Topic - Ill planned construction will cost more money than waiting for a more appropriate time

History - The following is a photo taken along Oxford Street East, between Industrial Road and Veterans Memorial Parkway.

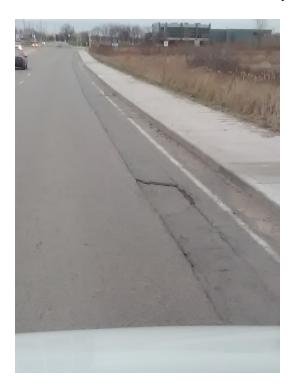
It is easy to see the 'joint' made on Oxford Street where the road was 'cut-back' to allow for the installation of sidewalk concrete forms!

I see two major problems here....

- 1) The 'joint' on the road surface runs exactly parallel with the right side tires of motor vehicles. If drivers try to avoid this 'joint' they are risking hitting the sidewalk or driving outside of their lane. Because of this, the 'joint' is receiving a lot of continuous stress. There are already many potholes along this stretch of road.... this photo is of the largest one!
- 2) The new road (that is from the 'joint' to the sidewalk has so much stress on it that it has already warped along the entire road. This warping of the asphalt collects water that freezes in the winter (making the road a greater hazard for drivers) and this collecting water also helps to create more potholes!

This sidewalk installation would have been more appropriately timed if it was scheduled to be built at the same time as this road was scheduled for repair or upgrading. It's that simple!
